**ON-SITE SEWAGE DISPOSAL SYSTEM
HOWARD COUNTY HEALTH DEPARTMENT
BUREAU OF ENVIRONMENTAL HEALTH**

Hubert Moore IS PERMITTED TO INSTALL X ALTER _____
ADDRESS _____ PHONE 031-5105
SUBDIVISION Slagle Property ROAD 16076-D. A. E. Mullinix LOT 7
PROPERTY OWNER Hubert Moore
ADDRESS _____

PLOT PLAN
OF LAND CONVEYED TO
ELISE M. NELSON
LIBER 864 FOLIO 428

EH-2-1186

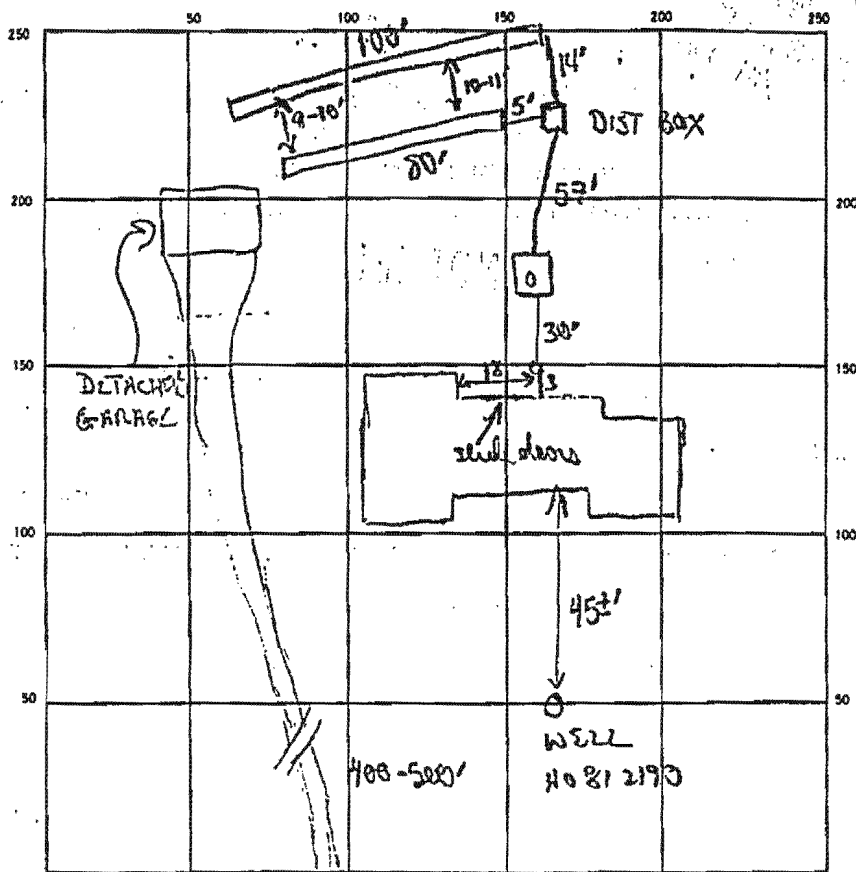
REMARKS 2/19/88 Back trench only 90' needs for the 100' long. Condition on
final install OK to cross line from house to dist box. OK
for and stone pipe paper for both trenches.

2-22-88 OK TO ADD GRAVEL TO BOTH TRENCHES S.M. 2-25-88 WORK NOT COMPLETE

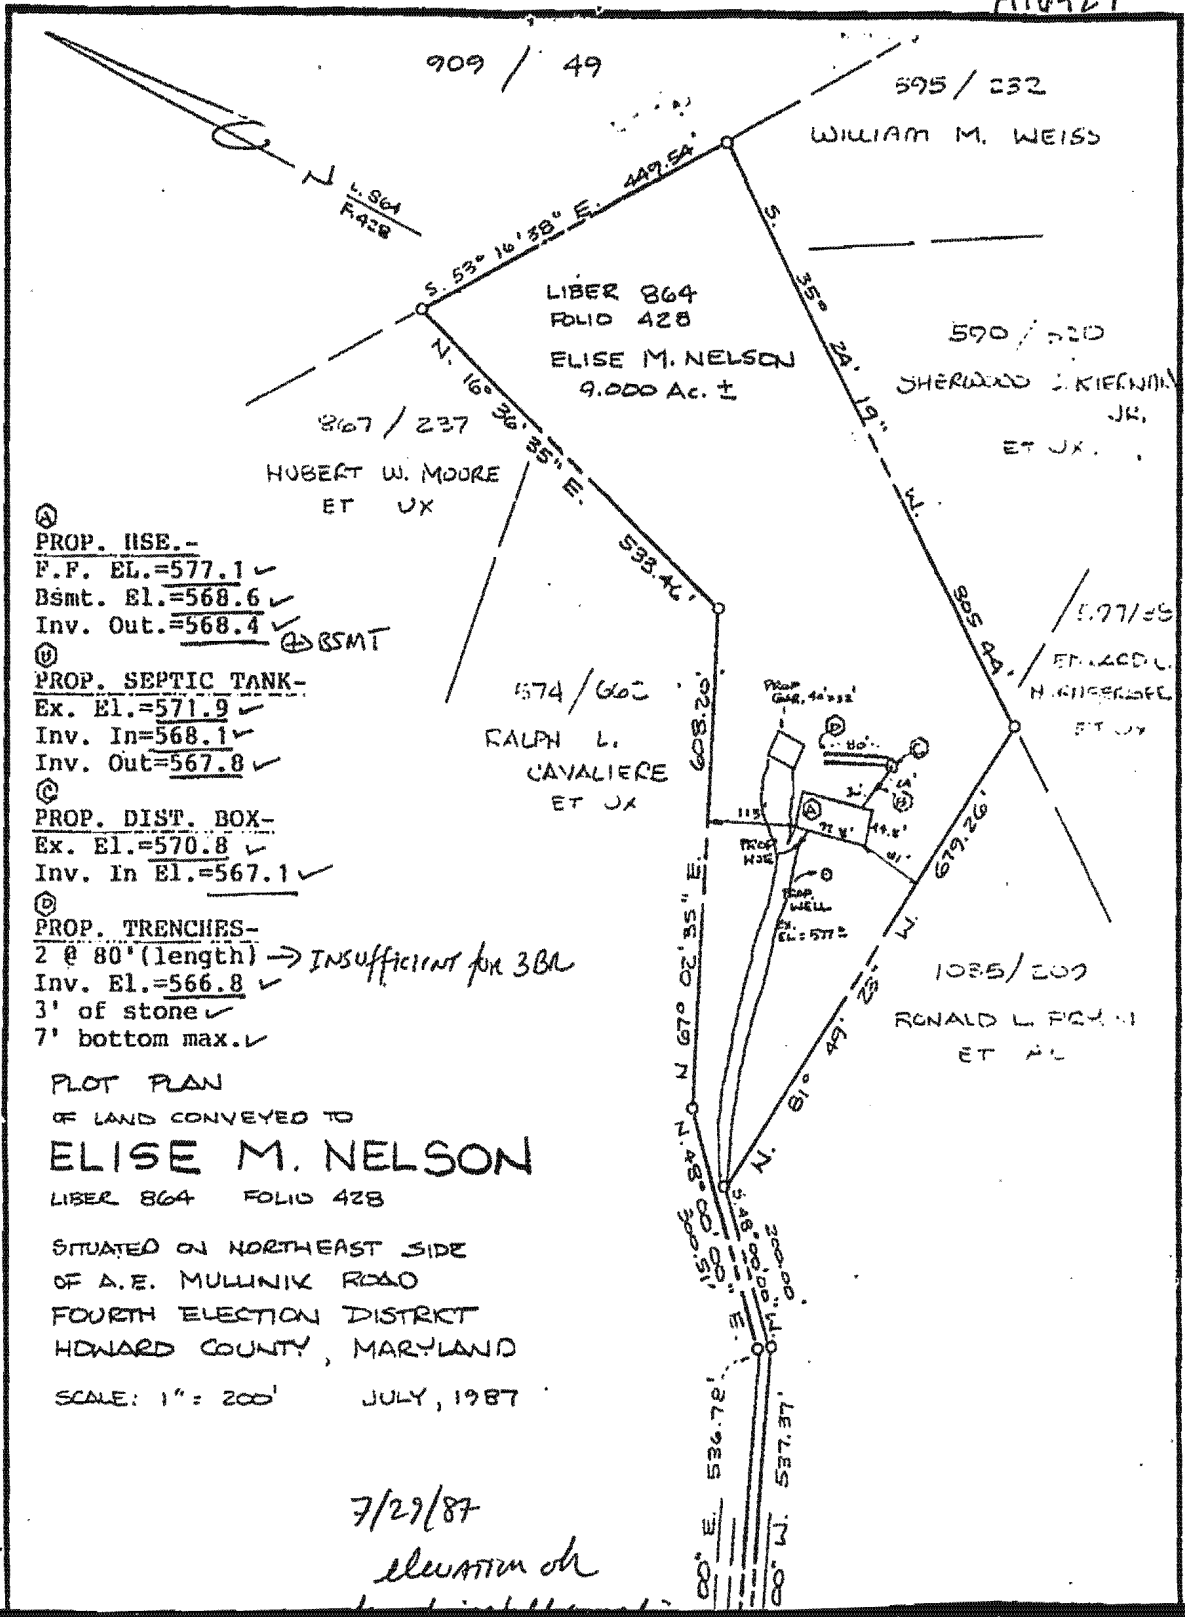
- ⓐ PROP. HSE.-
F.F. EL.=577.1 ✓
Bsmt. El.=568.6 ✓
Inv. Out.=568.4 ✓ ⊕ BSMT
- ⓑ PROP. SEPTIC TANK-
Ex. El.=571.9 ✓
Inv. In=568.1 ✓
Inv. Out=567.8 ✓
- ⓒ PROP. DIST. BOX-
Ex. El.=570.8 ✓
Inv. In El.=567.1 ✓
- ⓓ PROP. TRENCHES-
2 @ 80" (length) → *Insufficient for 3BA*
Inv. El.=566.8 ✓
3' of stone ✓
7' bottom max. ✓

7/29/87
elevation ok
